CITY OF ALBUQUERQUE

RE: Tierra Serena (Glendesto) Subdivision
Revised Grading Plan Stamp Date: 8/9/18
Drainage Supplement Stamp Date: none
Hydrology File: B18D020

GLENDESTO SUBDIVISION
GRADING & DRAINAGE PLAN

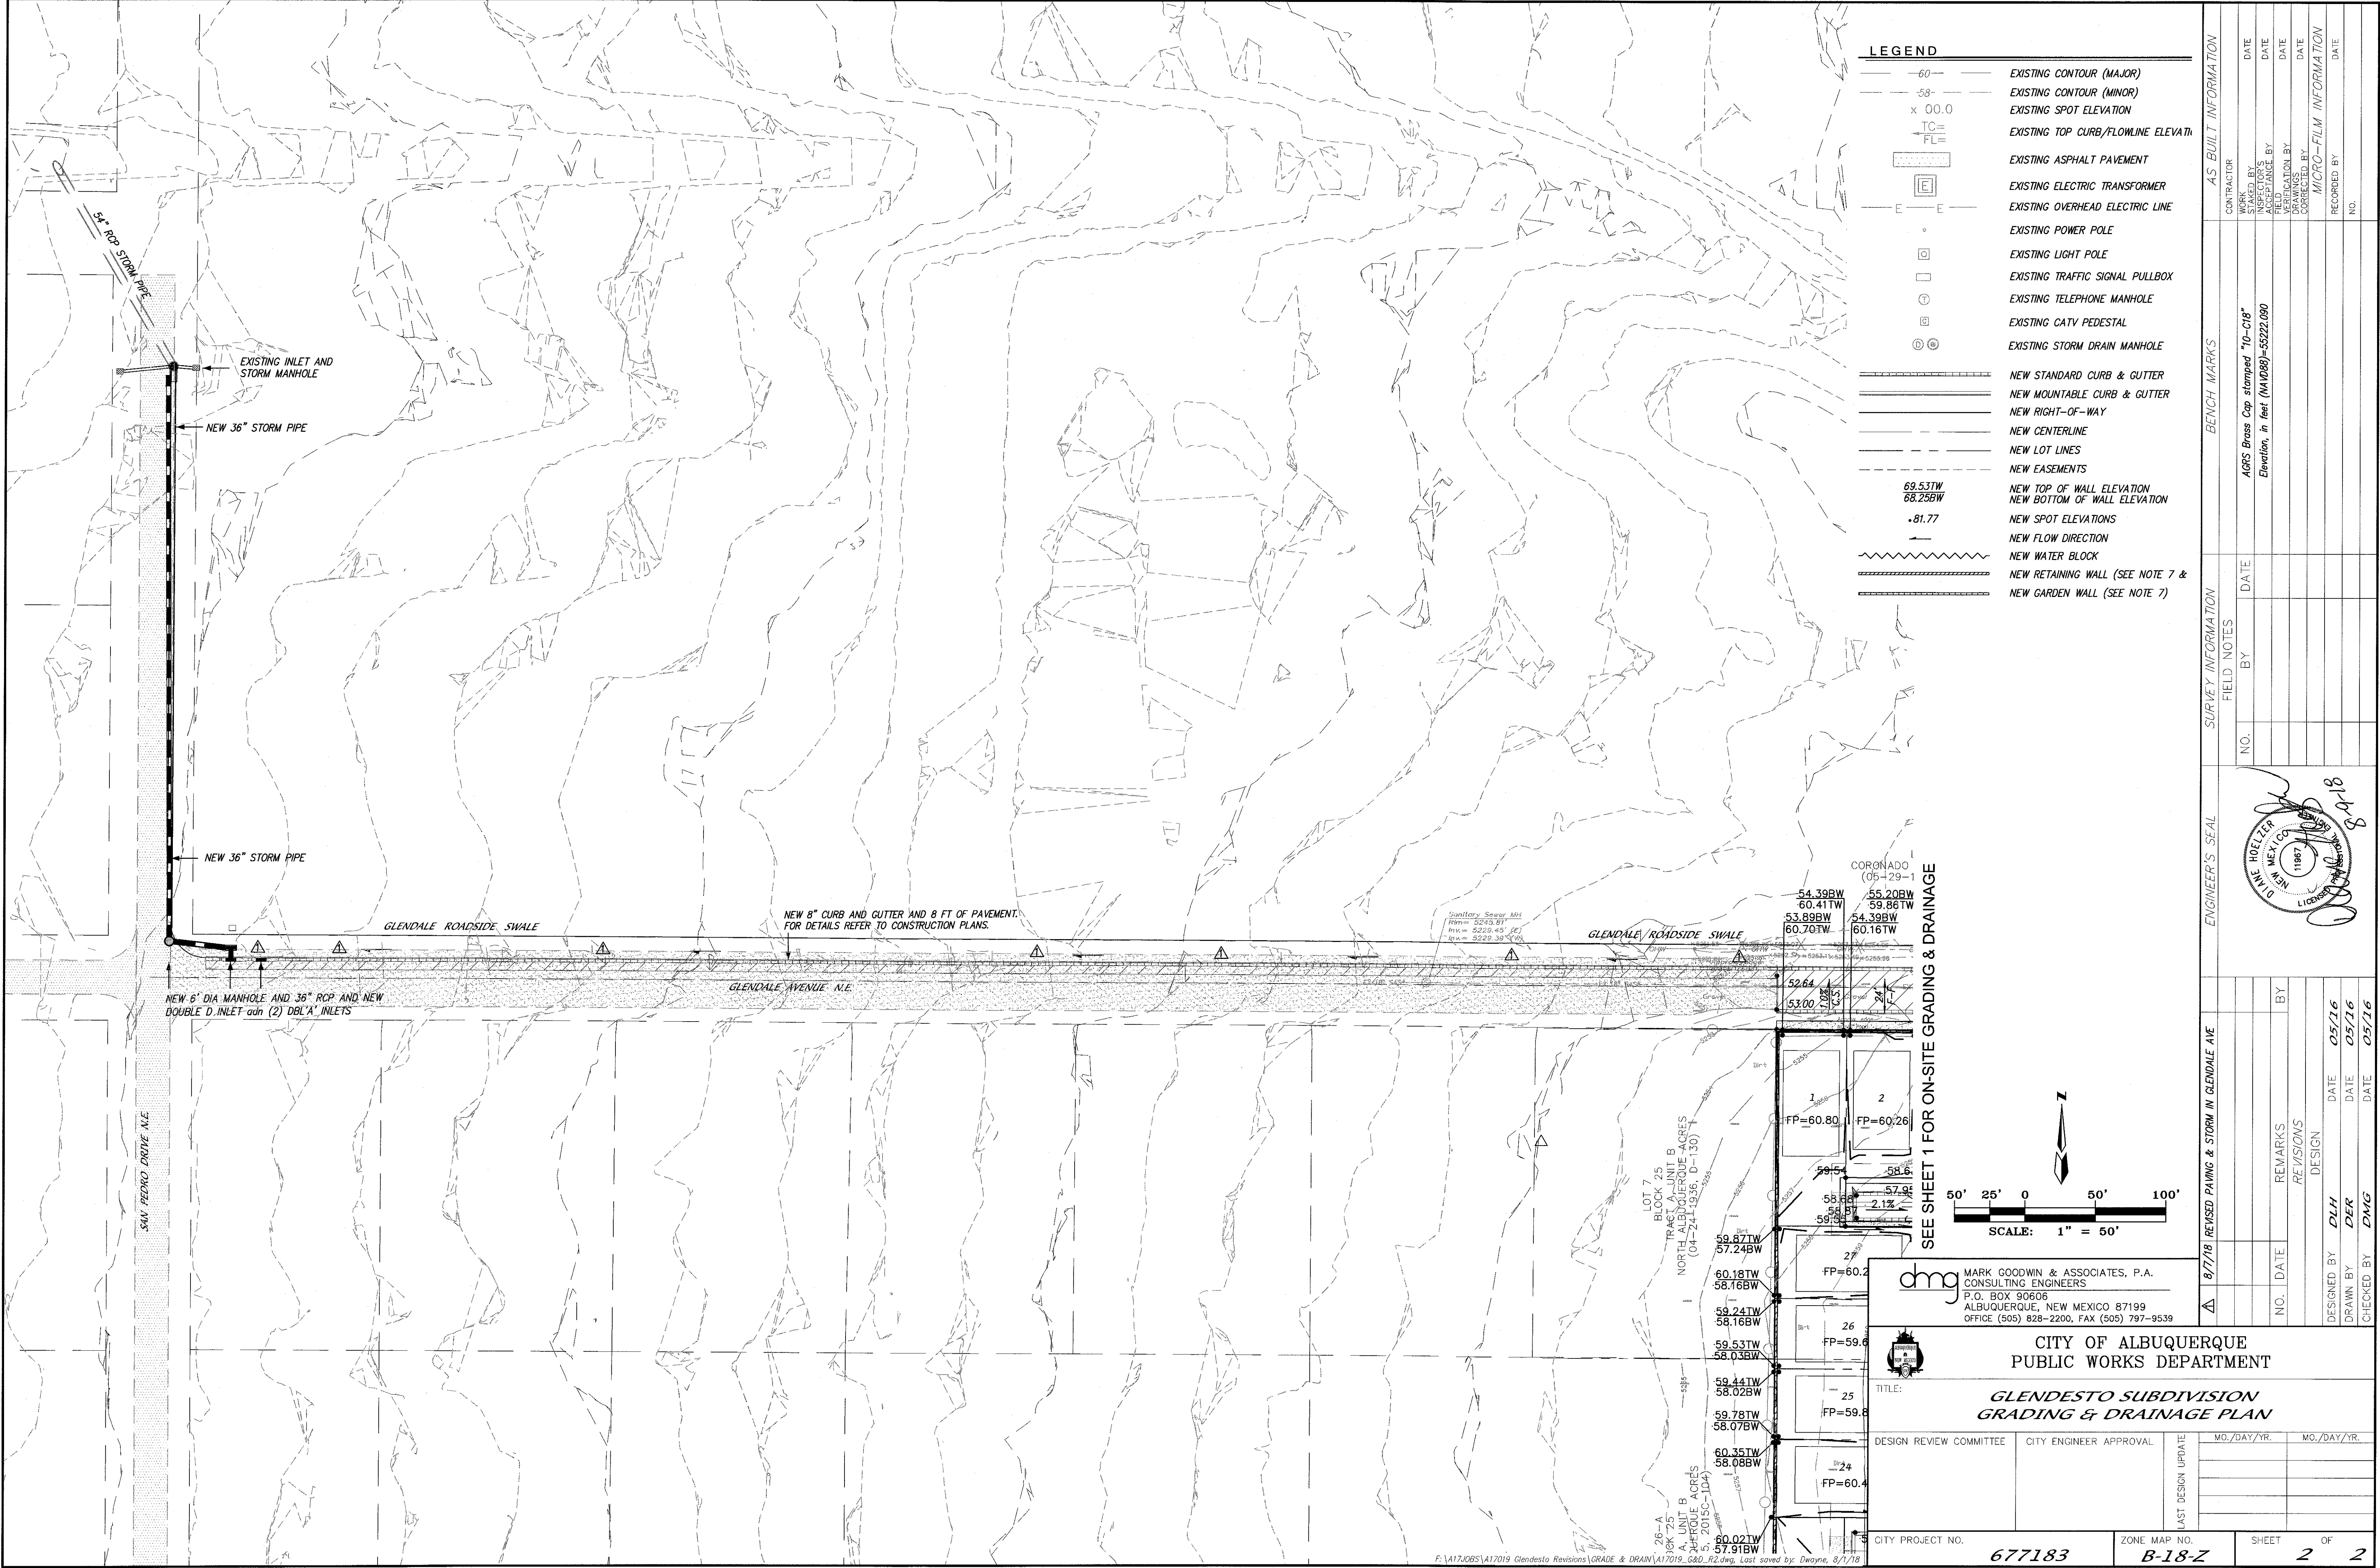
1. 100% interception of the 100-yr flow is required. No bypass will be allowed.
2. Provide HGL calculations and stormdrain profile for the revised stormdrain down the manhole at San Pedro/Glendale.
3. Provide street capacity calculations for the 10-yr storm. Demonstrate that it is contained on the asphalt section.
4. Date the drainage report supplement.
